**Development Special Use Permit #2018-0007,  
Transportation Management Plan Special Use  
Permit #2018-0062  
1200 N. Fayette Street**

## **I. SUMMARY**

### ***A. Recommendation***

Building 3B –East Elevation (facing N. Fayette St.)

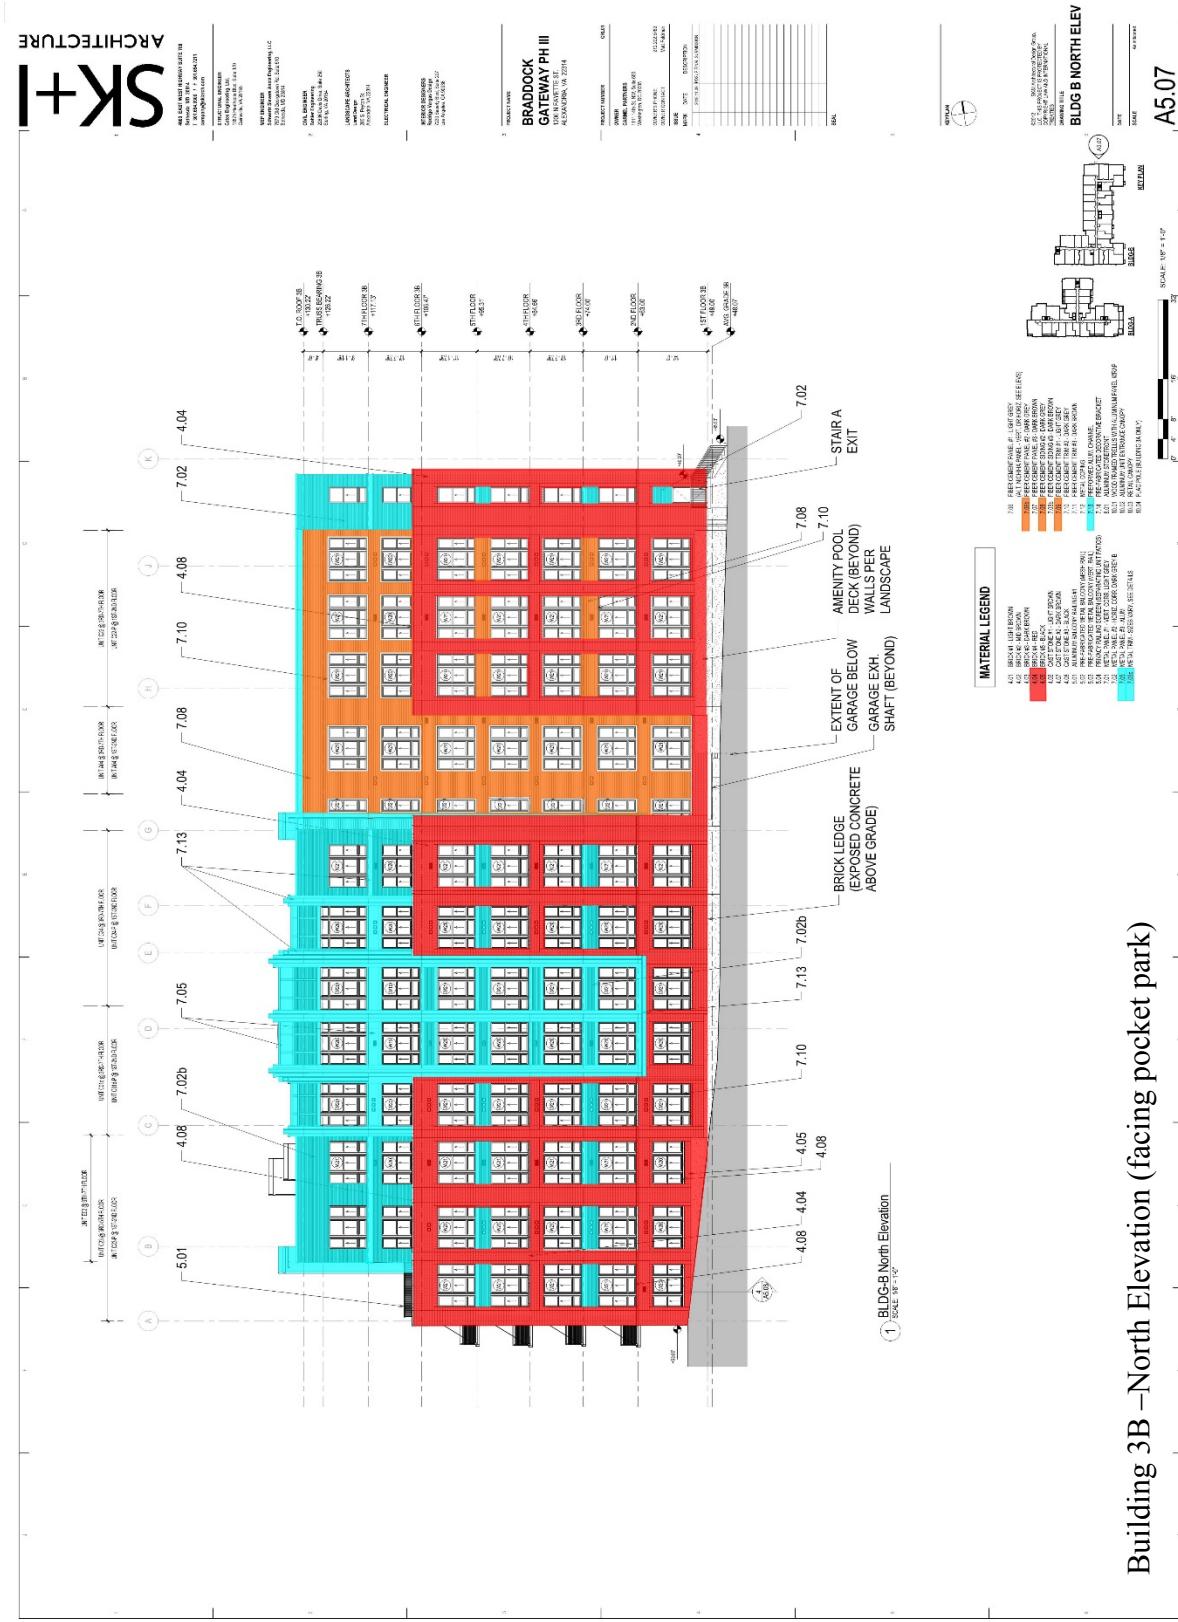
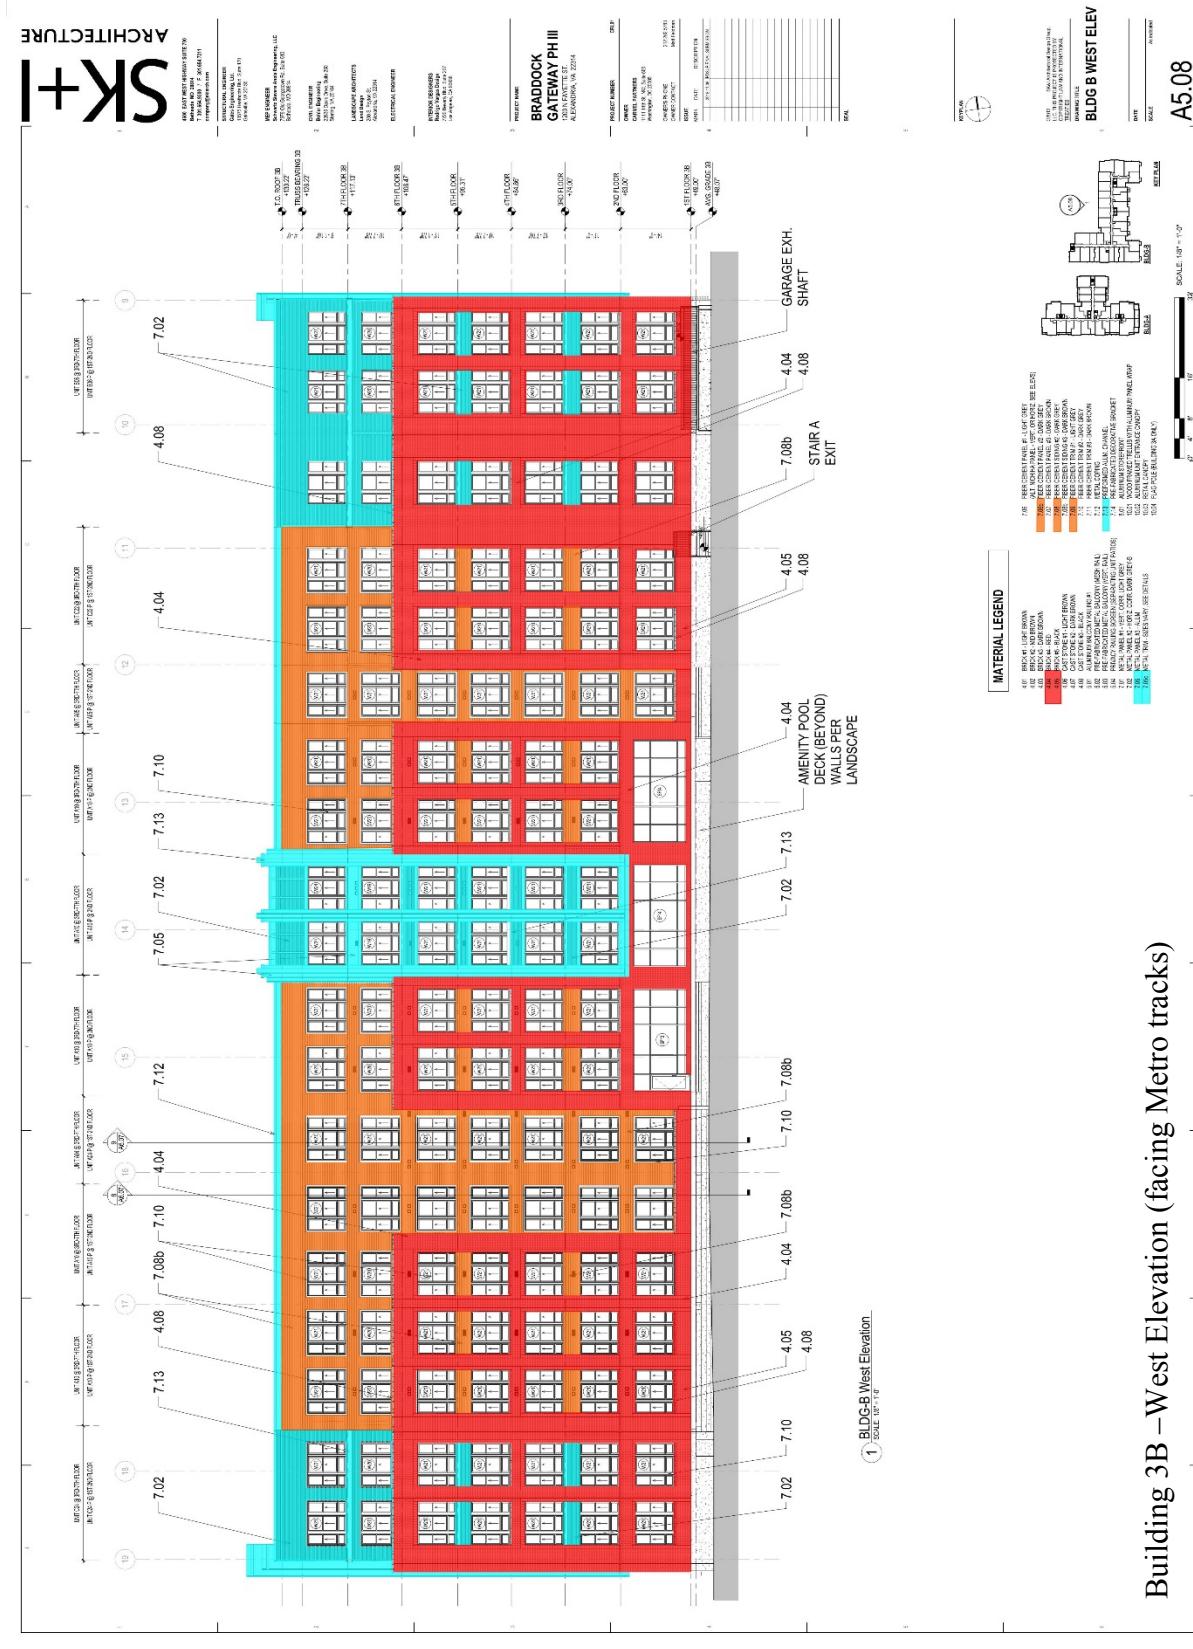
with the verticality of the upper floors of these facades topped with gray paneling. Due to the limited visibility of the west and north facades of Building 3A, Staff worked with the applicant to maximize masonry and metal materials on the south and east facades with some allowance for fiber-cement paneling where it is less visible. The material colors are primarily warm tones with cream and brown hues intermixed with gray paneling that provide contrast. The brown masonry creates a banding effect which assists with breaking down the scale and defining the base of the building.

The brick material on the first 5 floors continues around the less visible south and west facades, with gray paneling primarily utilized at the first 2 floors of the building and extended vertically at periodic interruptions of the brick to demarcate secondary entrances to the building and relate to the north and east facades. Following submission of the Preliminary Plan, the applicant contacted Staff to discuss revisions to the materials of Building 3B. The applicant described significant concerns for the project’s viability if some costs are not recouped due to the rising construction costs of today’s economy. Staff reviewed the revised materials in detail and worked closely with the applicant to ensure that any substitutions do not sacrifice the overall architectural and aesthetic quality of the building. This was done by limiting substitutions of metal for fiber cement paneling to the least visible facades to the south, facing the alley, and west, facing the metro tracks. Some fiber cement paneling is substituted for metal panel on the east façade; however, this area is set back from the road and only occurs on the recessed portion of the upper floors on the building, where its visibility is further minimized by the presence of a freestanding pergola at the seventh floor. Overall, the most prominent and visible areas of the building materiality remain unchanged, including the gateway feature and the most visible portions of the east façade. Graphics which diagram the changes are included as Attachments #2 and #3 at the end of this report.
